# UNITED STATES PATENT AND TRADEMARK OFFICE

APPLICATION NO.	FILING DATE	FIRST NAMED INVENTOR	ATTORNEY DOCKET NO.	CONFIRMATION NO.
09/314,052	05/18/1999	DOUGLAS E. OTT	15006.0009	4618

<b>Office Action Summary</b>	<b>Application No.</b> 09/314,052	<b>Applicant(s)</b> OTT ET AL.	
	<b>Examiner</b> Manuel A. Mendez	<b>Art Unit</b> 3763

## **DETAILED ACTION**

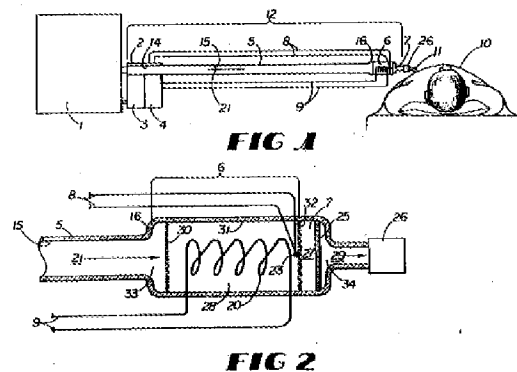
In relation to claim 82, in figures 1 and 2, the Ott patent shows an inlet (14), a humidification device (6) in fluid communication with the inlet (14), a humidification material (30, 32) placed in a shell (16), and an outlet (29). The Ott patent does not explicitly disclose a humidification material "that readily absorbs moisture and readily releases moisture when exposed to a dry environment". However, in the REMARKS, page 5, starting in line 20, applicant defines such material as:

In view of the above definition, in figure 2, the Ott patent shows in chamber (6), a gas-permeable membrane (30), a gas-permeable membrane (32), and a water-containing humidifying bed (28) wherein the water is retained in the bed by the two gas-permeable membranes that allow gas to flow, but restrict the flow of liquids. The use of the membranes is further defined in column 6, lines 35-36 and lines 44-51. Therefore, based on the teachings of Ott and the definition disclosed in the REMARKS, it can be concluded that the gas-permeable membranes disclosed in the Ott patent are capable of readily absorbing moisture and readily releasing moisture when exposed to a dry environment.

Accordingly, following the applicant's line of reasoning, the “flowing gas” illustrated in figure 2 above by numerical (21), experiences turbulence when the gas encounters a change in direction<sup>1</sup> and/or when the gas encounters obstacles<sup>2</sup> that impede free-

<sup>1</sup> In figure 2, as the gas flows to the distal end of the apparatus, turbulence is created as the gas moves from a lumen of smaller diameter to a lumen of greater diameter near the first gas-permeable membrane (30), and similarly, as the gas moves from a lumen of greater diameter to a lumen of smaller diameter in the area distal to filter (25).

<sup>2</sup> In figure 2, the gas will experience turbulence as it flows through gas-permeable membrane (30), optional gas-permeable membrane (32), and filter (25).

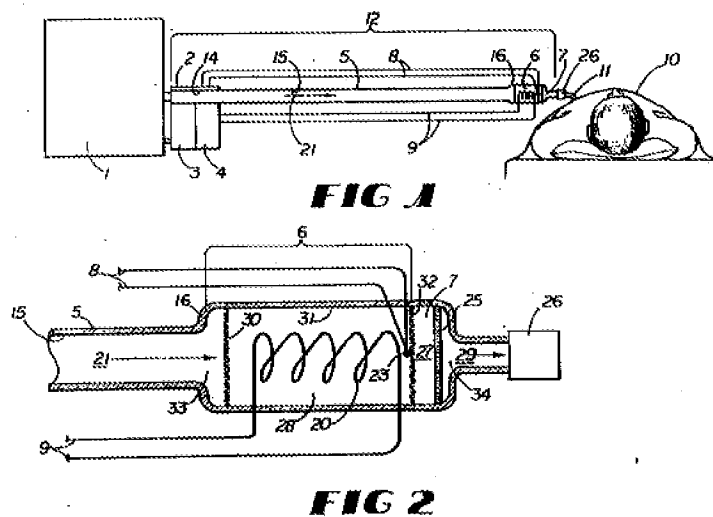
In relation to claim 83, in figures 1 and 2, the Ott patent shows an inlet (14), a humidification device (6) in fluid communication with the inlet (14), a heater housing

comprising a heater (20) having a plurality of openings for the gas to flow in view of the spiral shape of the heater, a humidification material (30, 32) placed in a shell (16), and an outlet (29). The Ott patent does not explicitly disclose a humidification material “that readily absorbs moisture and readily releases moisture when exposed to a dry environment”. However, in the REMARKS, page 5, starting in line 20, applicant defines such material as:

In view of the above definition, in figure 2, the Ott patent shows in chamber (6), a gas-permeable membrane (30), a gas-permeable membrane (32), and a water-containing humidifying bed (28) wherein the water is retained in the bed by the two gas-permeable membranes that allow gas to flow, but restrict the flow of liquids. The use of the membranes is further defined in column 6, lines 35-36 and lines 44-51. Therefore, based on the teachings of Ott and the definition disclosed in the REMARKS, it can be concluded that the gas-permeable membranes disclosed in the Ott patent are capable of readily absorbing moisture and readily releasing moisture when exposed to a dry environment.

Accordingly, following the applicant's line of reasoning, the "flowing gas" illustrated in figure 2 above by numerical (21), experiences turbulence when the gas encounters a change in direction<sup>3</sup> and/or when the gas encounters obstacles<sup>4</sup> that impede free-flowing gas characteristics. Therefore, it would not be unreasonable to conclude that the Ott patent discloses "a configuration that generates turbulence in a gas as it passes over a surface of said shell."

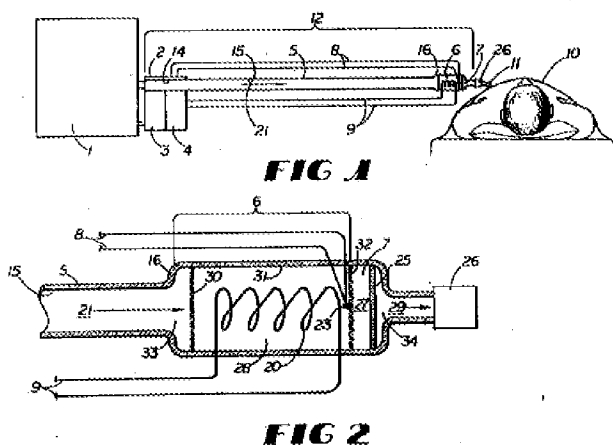
In relation to claim 84, in figures 1 and 2, the Ott patent shows an inlet (14), a heater (20) in communication with the inlet, a temperature sensor (23), a humidification material (30, 32) placed in a shell (16), and an outlet (29). The Ott patent does not explicitly disclose a humidification material "that readily absorbs moisture and readily releases moisture when exposed to a dry environment". However, in the REMARKS, page 5, starting in line 20, applicant defines such material as:

In view of the above definition, in figure 2, the Ott patent shows in chamber (6), a gas-permeable membrane (30), a gas-permeable membrane (32), and a water-containing

Accordingly, following the applicant’s line of reasoning, the “flowing gas” illustrated in figure 2 above by numerical (21), experiences turbulence when the gas encounters a change in direction<sup>5</sup> and/or when the gas encounters obstacles<sup>6</sup> that impede free-flowing gas characteristics. Therefore, it would not be unreasonable to conclude that the Ott patent discloses “a configuration that generates turbulence in a gas as it passes over a surface of said shell.”

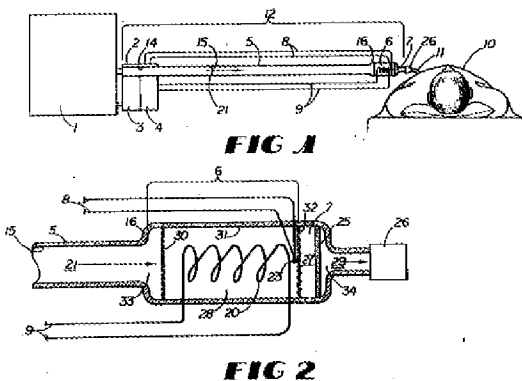
In figure 2 above, the Ott patent shows a gas-permeable membrane (30) having a single layer, a gas-permeable membrane (32) having a single layer, and a filter (25). Based on the teachings of the Ott patent, humidification material having single layers would have been considered conventional in the art at the time the invention was made. Moreover, in view of the proven conventionality of this particular structural element, the

Finally, the phrase “unbundled to any other humidification material” could be interpreted as having multiple layers of different materials. In figure 2, the Ott patent shows at the most distal end of the apparatus, a gas-permeable membrane (32) working in combination with a filter (25). Both, the gas-permeable membrane and the filter are made of different materials demonstrating the conventionality of having embodiments with multiple layers made of different materials.

Accordingly, following the applicant’s line of reasoning, the “flowing gas” illustrated in figure 2 above by numerical (21), experiences turbulence when the gas encounters a change in direction<sup>8</sup> and/or when the gas encounters obstacles<sup>9</sup> that impede free-flowing gas characteristics. Therefore, it would not be unreasonable to conclude that the

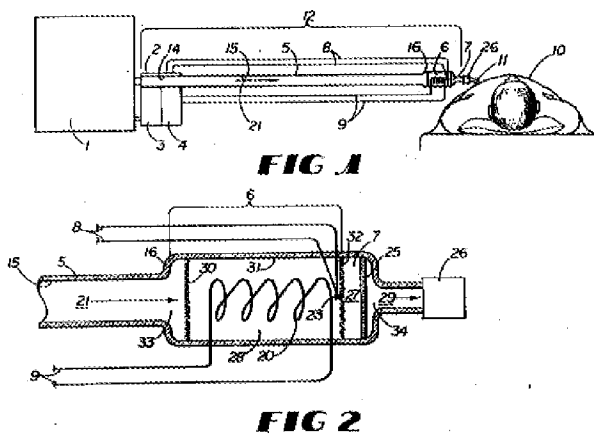
In relation to claim 86, in figures 1 and 2, the Ott patent shows an inlet means for supplying a gas (14), outlet means (29), and a humidification material (30, 32) placed in a shell (16). The Ott patent does not explicitly disclose a humidification material “that readily absorbs moisture and readily releases moisture when exposed to a dry

In view of the above definition, in figure 2, the Ott patent shows in chamber (6), a gas-permeable membrane (30), a gas-permeable membrane (32), and a water-containing humidifying bed (28) wherein the water is retained in the bed by the two gas-permeable membranes that allow gas to flow, but restrict the flow of liquids. The use of the membranes is further defined in column 6, lines 35-36 and lines 44-51. Therefore, based on the teachings of Ott and the definition disclosed in the REMARKS, it can be concluded that the gas-permeable membranes disclosed in the Ott patent are capable of readily absorbing moisture and readily releasing moisture when exposed to a dry environment.

Accordingly, following the applicant's line of reasoning, the "flowing gas" illustrated in figure 2 above by numerical (21), experiences turbulence when the gas encounters a

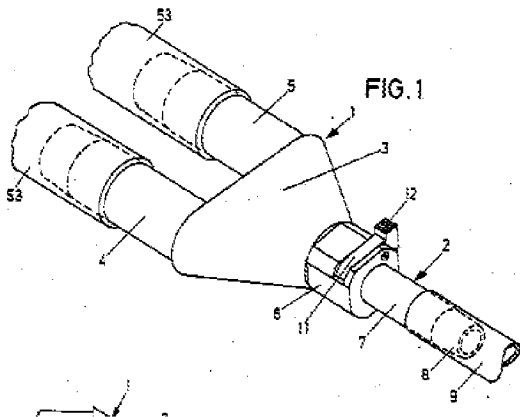
made as evidenced by the teachings of Riighheimer. The Riighheimer patent shows in figure 1 above, the use of two inlets (4, 5) designed to infuse and mix different fluids.

Accordingly, for a person of ordinary skill in the art, modifying the apparatus disclosed by Ott with a second inlet, as taught by Riighheimer, would have been considered obvious because a second inlet would have permitted the infusion and mixing of different gases, enhancing the capabilities of the apparatus.
